**Re: Second Submission Review** – Harvest Crossing PA 5, 6, & 7 – Master Plan Amendment, Site Plan, & Plat  
Application Number: **DA-1786-03**  
Case Numbers: **2005-7007-03, 2022-4017-00, 2022-3049-00**

*Second Submission Review*

# HARVEST CROSSING SUBDIVISION FILING NO. 2

SHEET 1 OF 12

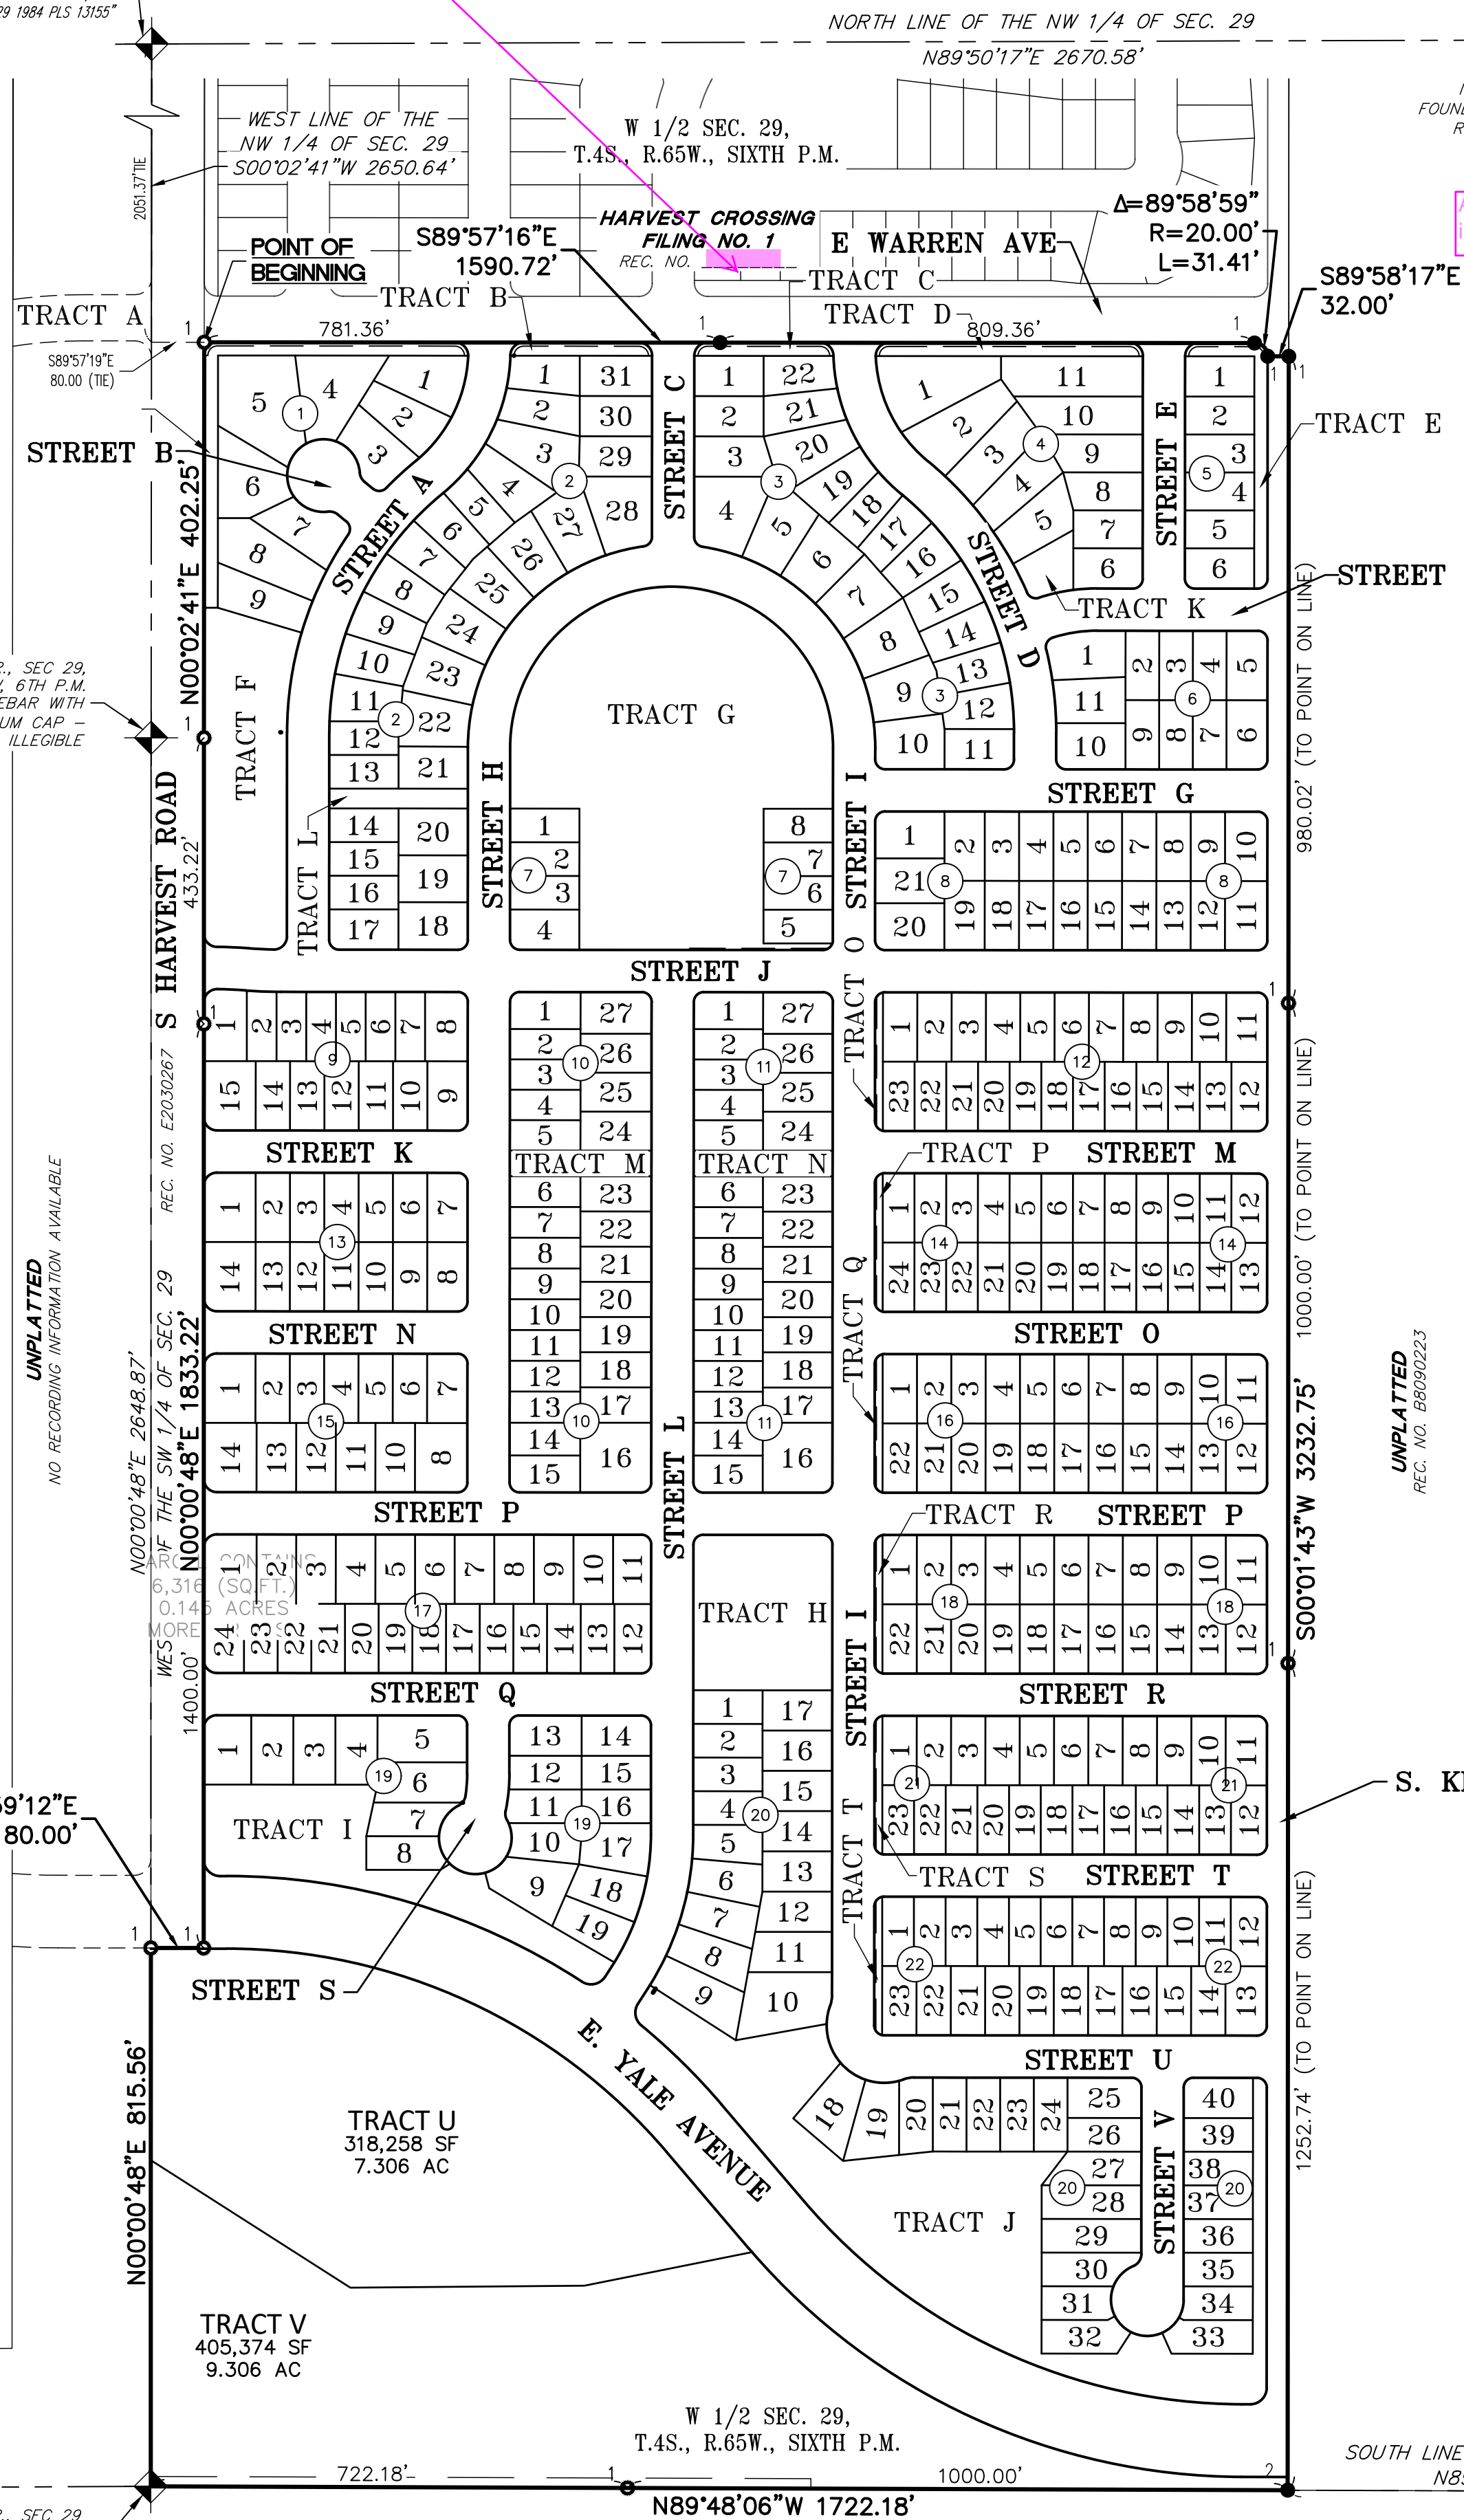
17A. Send in the State Monument Records for the aliquot corners used in the plat.

17B. Send in the Certificate of Taxes Due. Show they are paid in full up to and through the plat approval date of recording. Obtained from the County Treasurer's office.

17C. Need reception #.

17D. Need a date here.

17E. Send in the copy of the Deed of Trust document showing this Mortgage Holder, this is not shown in the Title Commitment.

Send in the Certificate of Taxes Due show they are paid in full up to and through the plat approval date of recording. Obtained from the County Treasurer's office.

**Aztec: Monuments records included with submittal.**

**Aztec: Certificate of Taxes Due will be submitted with the following submittal.**

**Aztec: Plat yet to be recorded**

**Aztec: To be added when mylars are printed**

**Aztec: Signature block removed**

to be added when printed to mylars

SHEET 2 OF 12

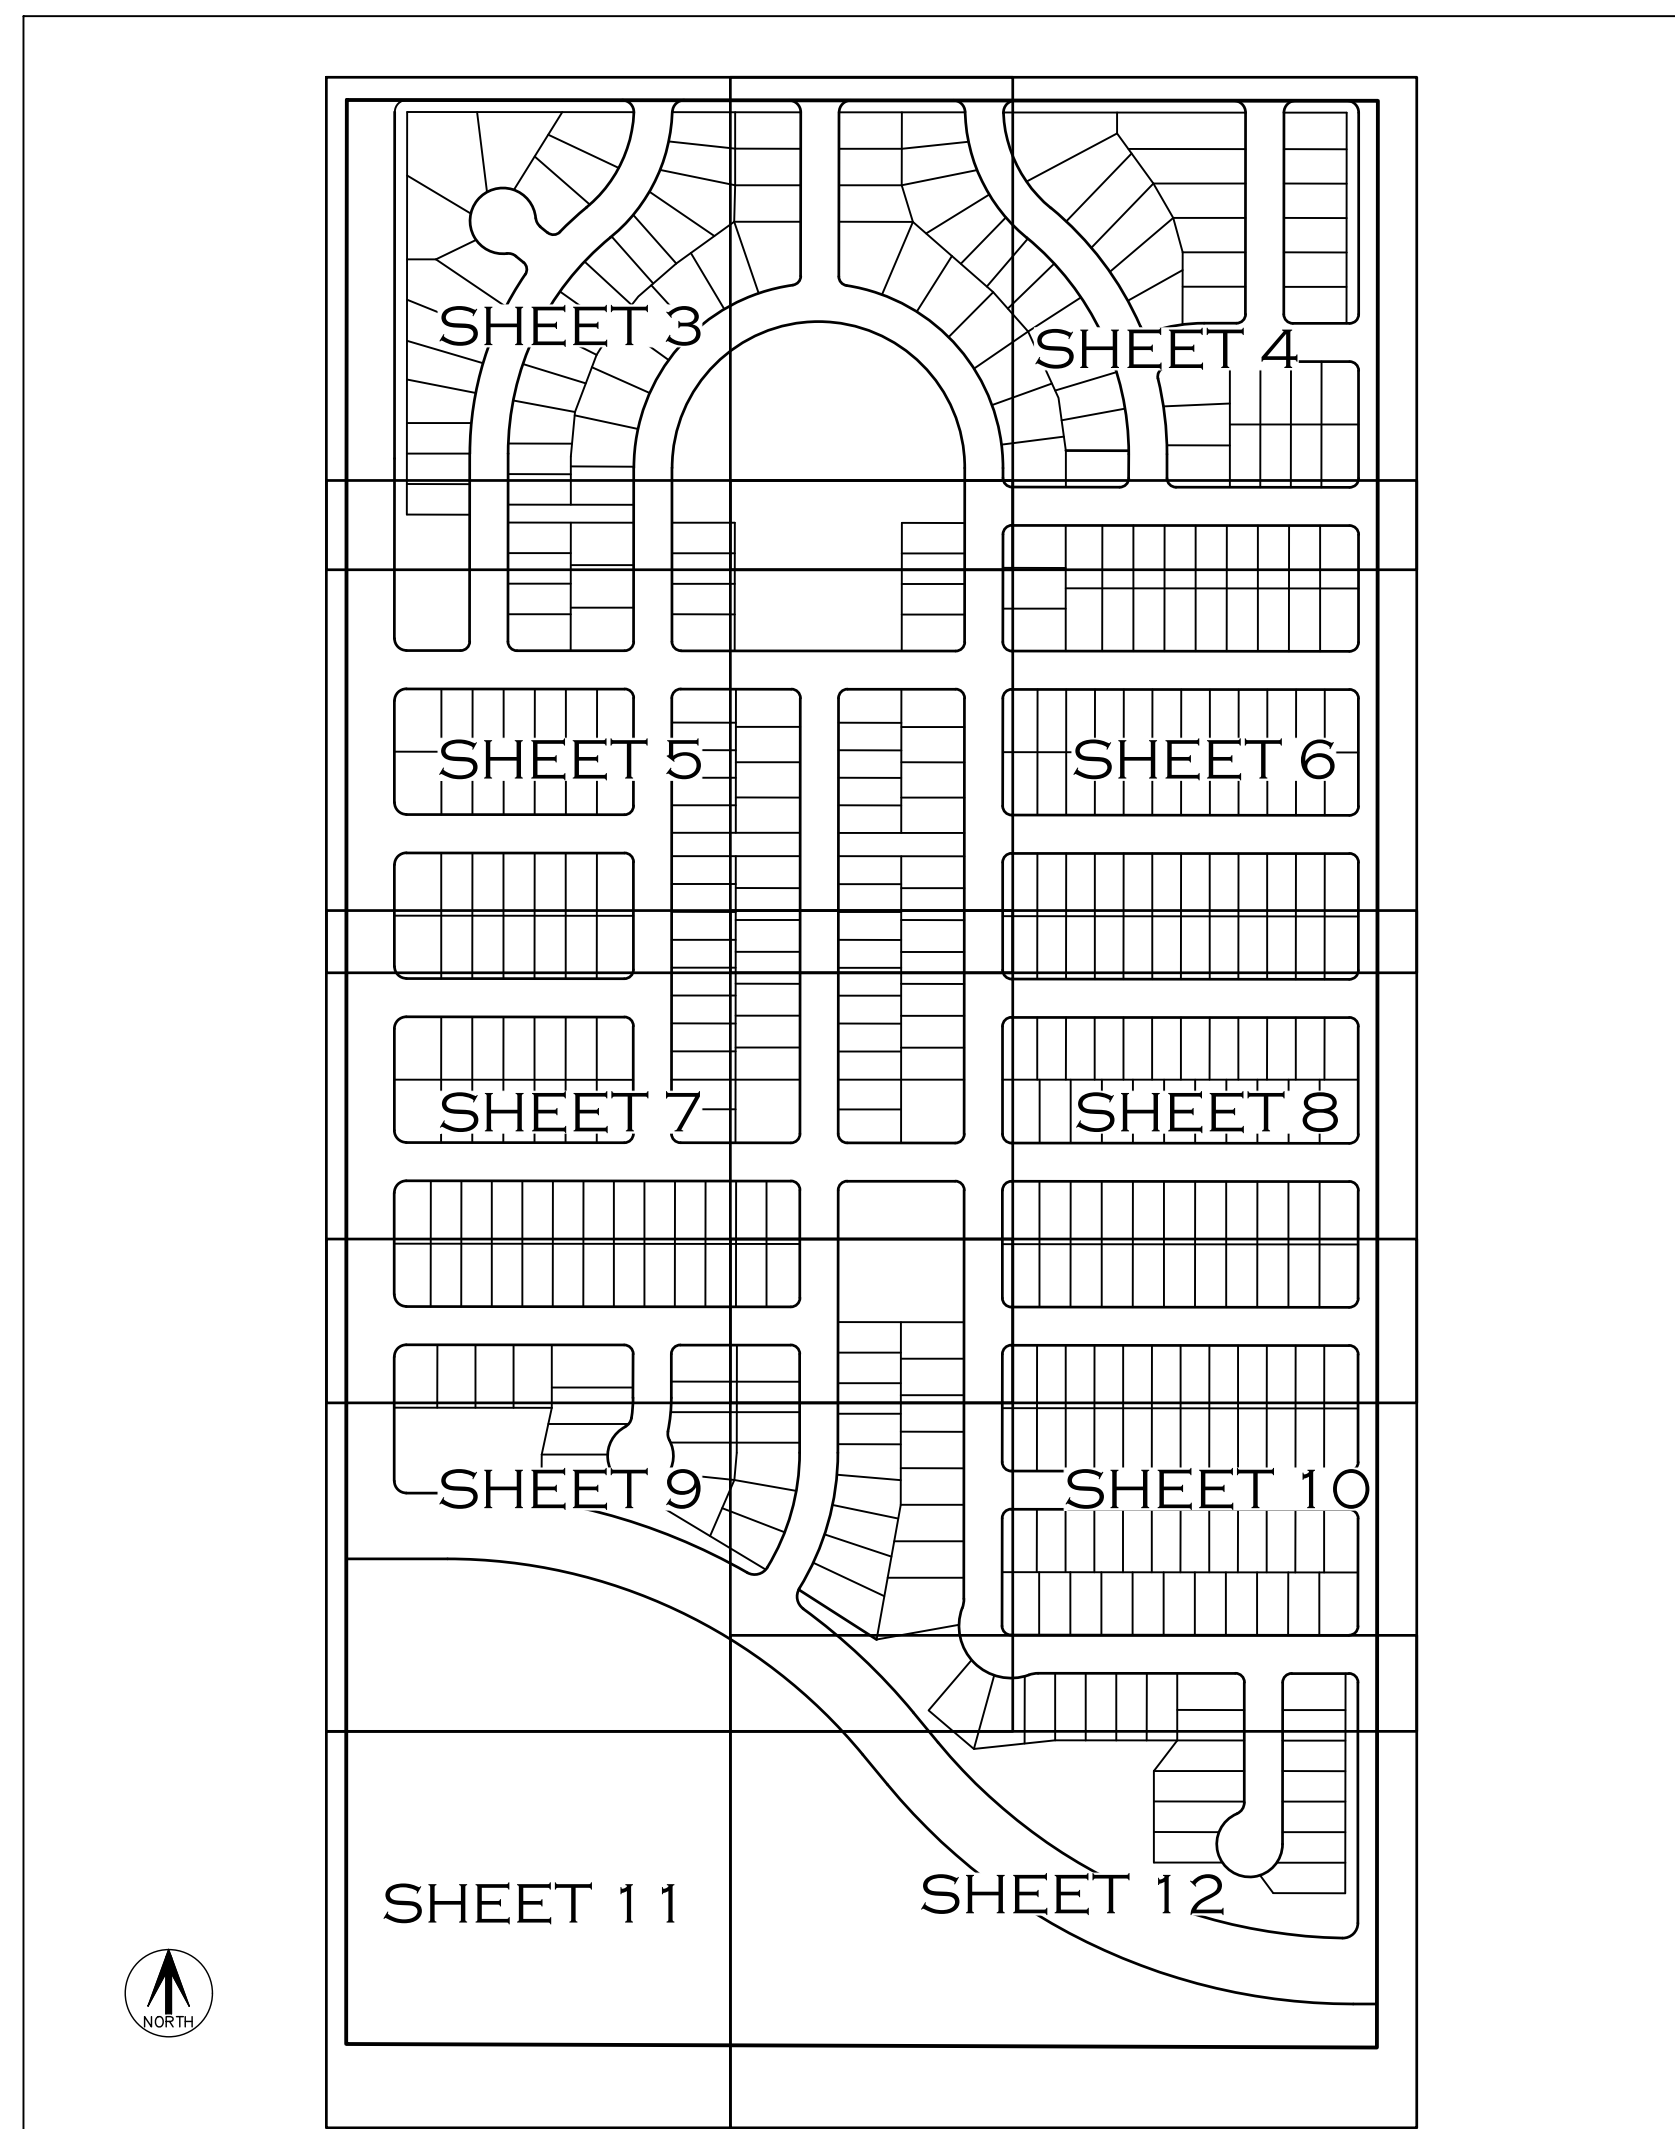
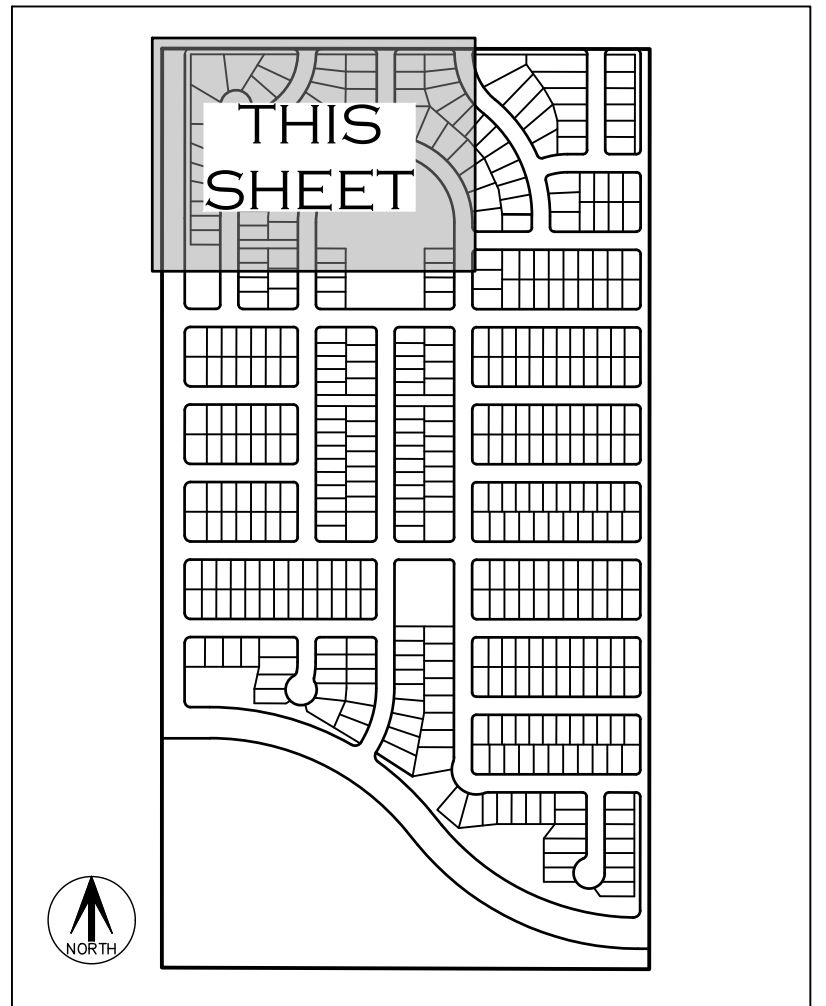
17F. Add recording info.

17G. Are there street names instead of street letters?

Add recording info

**Aztec: Plat yet to be recorded**

**Aztec: Street names added**

plat yet to be  
recorded

street names added
